License No. 06-00217-06  
Docket No. 030-03754

Subject: **License Amendment Request**

**License Amendment Application**

**Application for Amendment  
US NRC License Number 06-00217-06  
Docket Number 030-03754**

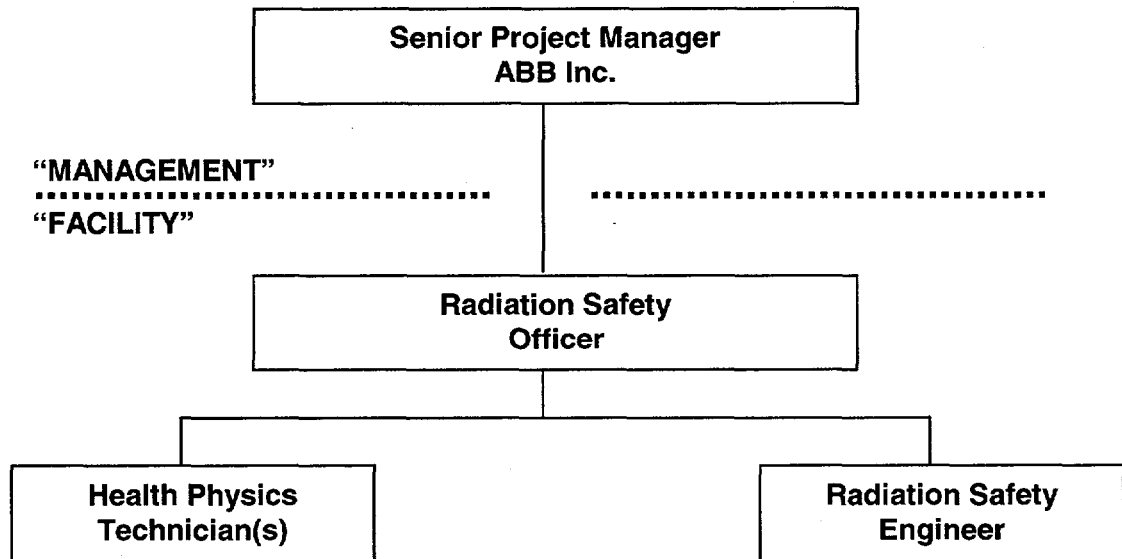
- Page 4, Section 7.1:
  - Change section title to "Management" to more accurately reflect content of the section.
  - The organization chart is modified to be consistent with NRC License No. SNM-1067 and reflect contemporary site conditions.

- Change "CORPORATE" in organization chart to "MANAGEMENT" to more closely align chart terminology with that of text in the section.
  - Under Note 1, add RSO as a part-time function, since all facilities under the Decommissioning Plan have been removed, thus eliminating virtually all authorized work with licensed material. FUSRAP areas and buildings will remain until the U.S. Army Corps of Engineers authorizes removal action.

Figure 9-1

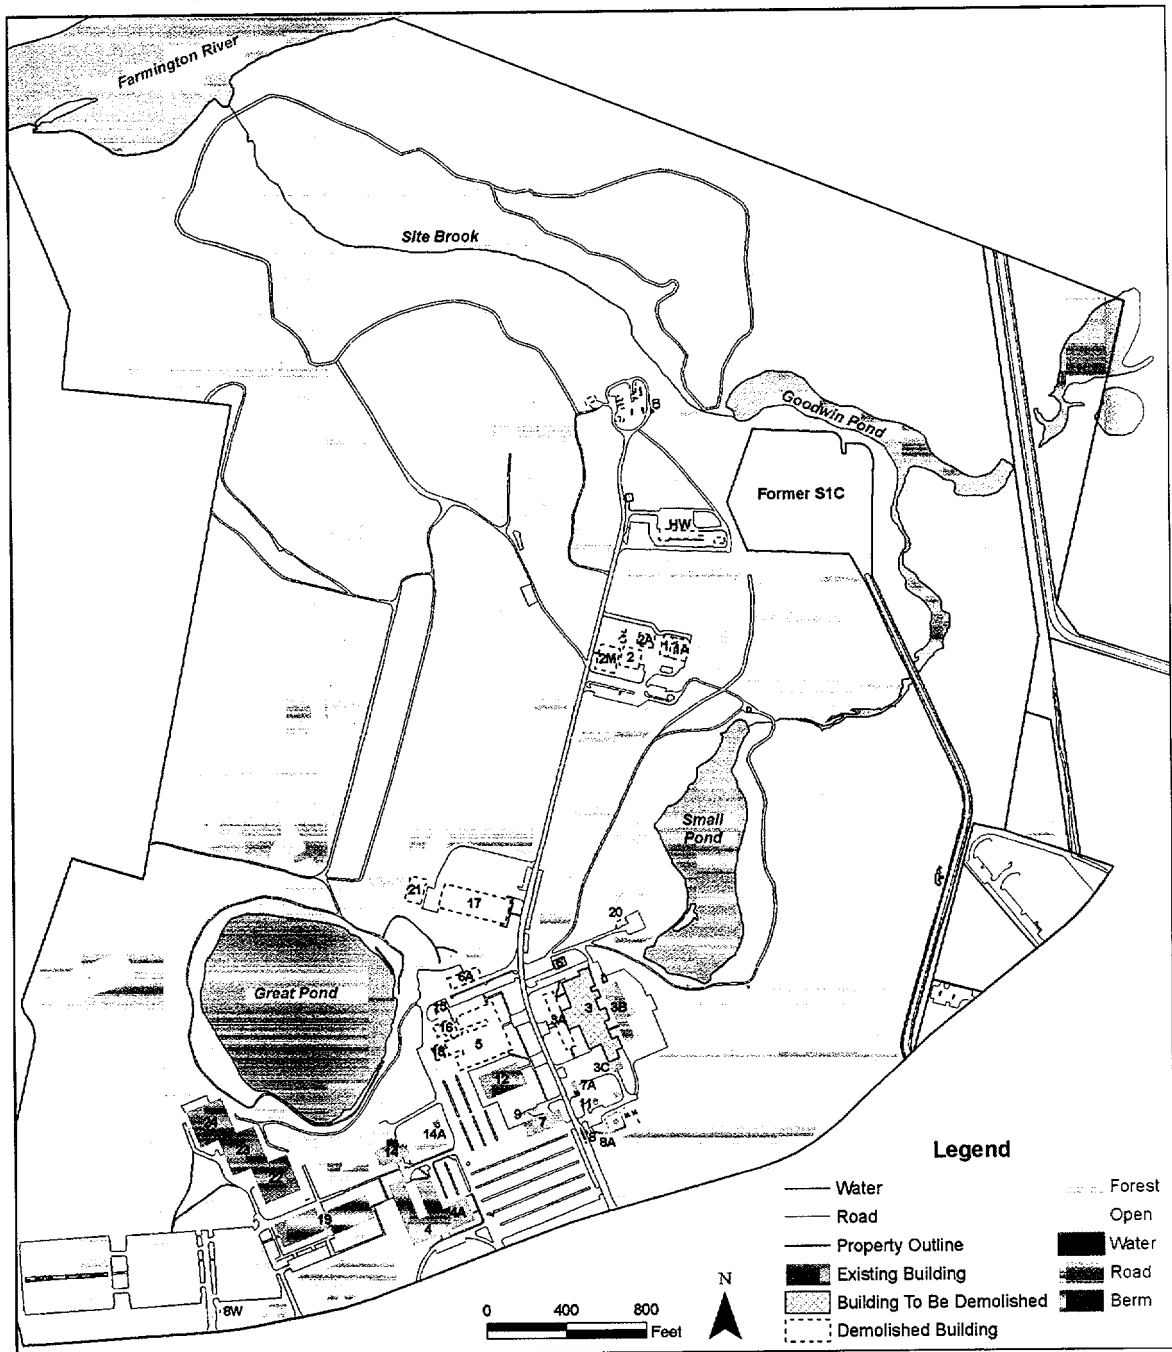
- Page 13, Figure 9.1: The CE Site Plan has been updated and revised to depict removed buildings.
- Page 14, Section 10.1: In paragraph two, the reference to Regulatory Guide 1.86 (1974) in the second sentence is changed to reflect a more contemporary version of the Guide, dated April 1993 and be consistent with NRC License SNM-1067.
